# PRODUCT CHANGE NOTICE

1. TITLE <b>IRFY140C/CM Electrical Characteristics</b>		2. DOCUMENT NUMBER <b>FV5-C-19-0058</b>
		3. DATE <b>April 30, 2019</b>
4. MANUFACTURER AND ADDRESS <b>International Rectifier HiRel Products, Inc 205 Crawford Street Leominster, MA 01453</b>		5. MANUFACTURER PART NUMBER <b>See below for IR Part Numbers</b>
		6. BASE PART <b>NA</b>
		7. NATIONAL STOCK NUMBER (NSN) <b>NA</b>
8. CAGE <b>69210</b>	9. EFFECTIVE DATE <b>April 30, 2019</b>	10. GOVERNMENT NUMBER <b>NA</b>
11. POINT OF CONTACT <b>Manufacturer's Representative or Account Specialist (978) 534-5776</b>		12. DRAWING NUMBER <b>NA</b>
		13. SPECIFICATION NUMBER <b>MIL-PRF-19500</b>

## IRFY140C/CM

100V Single N-Channel Hi-Rel MOSFET in a TO-257AA package

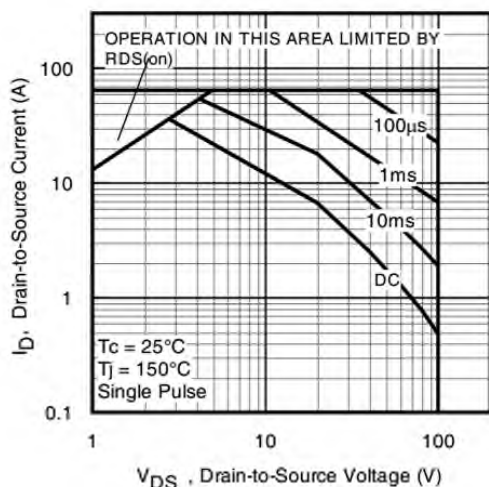
Updating SOA curve to match SOA re-characterization data
